Application 2024-098489 Frome St John the Baptist Glazed doors

Responses to comments from other organisations

Appendix: Increased welcome—distance from thoroughfare

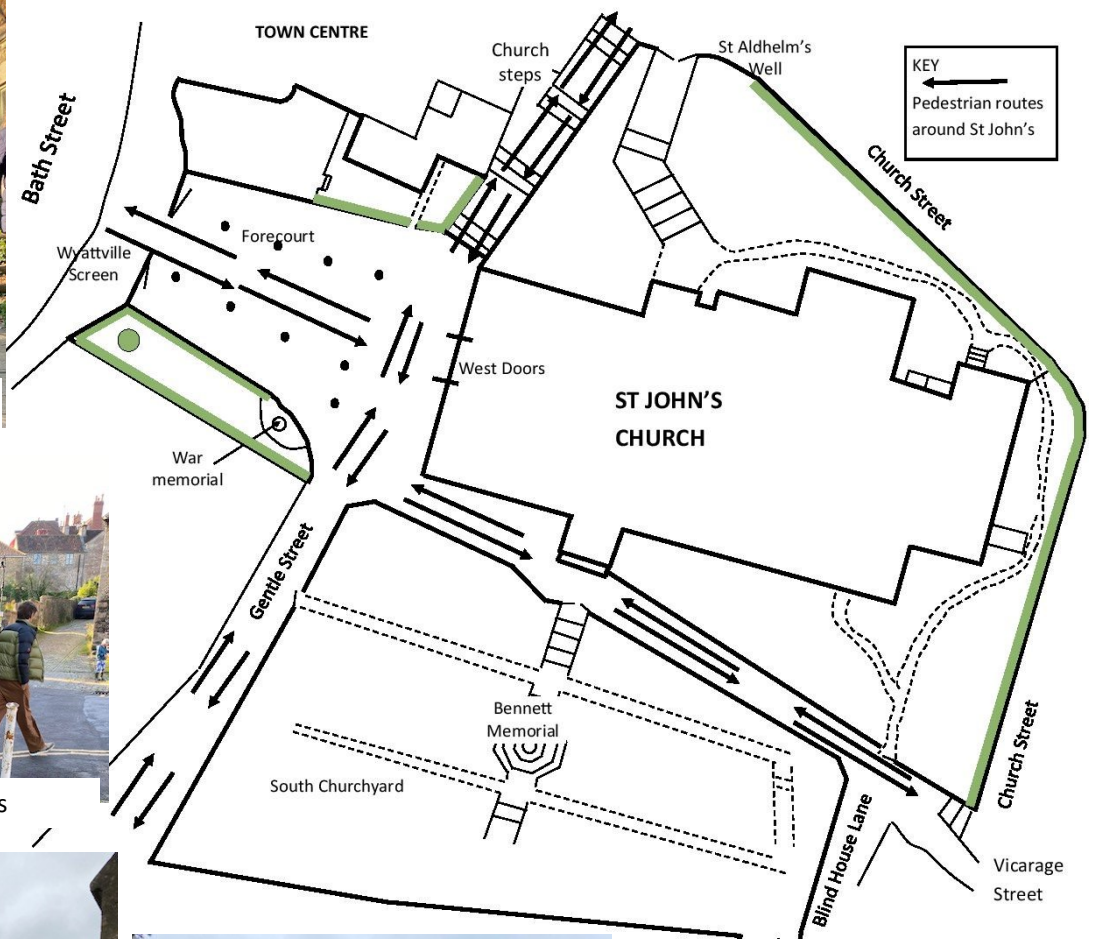
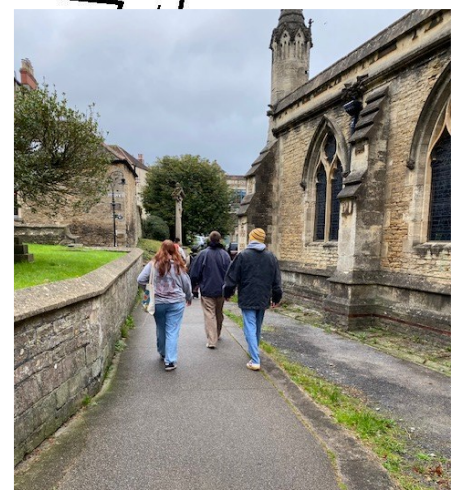
The Victorian Society comments: *While such doors are transparent the level of visibility into a church they provide can vary greatly depending on ... distance from a public thoroughfare. ... due to the distance of the entrance from Bath Street it is unlikely views would be noticeable to passers by during daylight hours.*

In fact, many, many people pass very close to our west doors every day. We agree that Bath Street is the main vehicular thoroughfare into and out of the town from the south side of town, but it is not the main pedestrian thoroughfare. The main pedestrian thoroughfare is down Gentle Street, across our forecourt – which means passing within inches of our west doors – and down Church Steps. The map and photos show this, and also another important pedestrian route – and a noted ‘school run’ – from Vicarage Street along the path alongside the south side of the church into our forecourt – again passing very close to our west doors – then on through across our forecourt and across Bath Street.
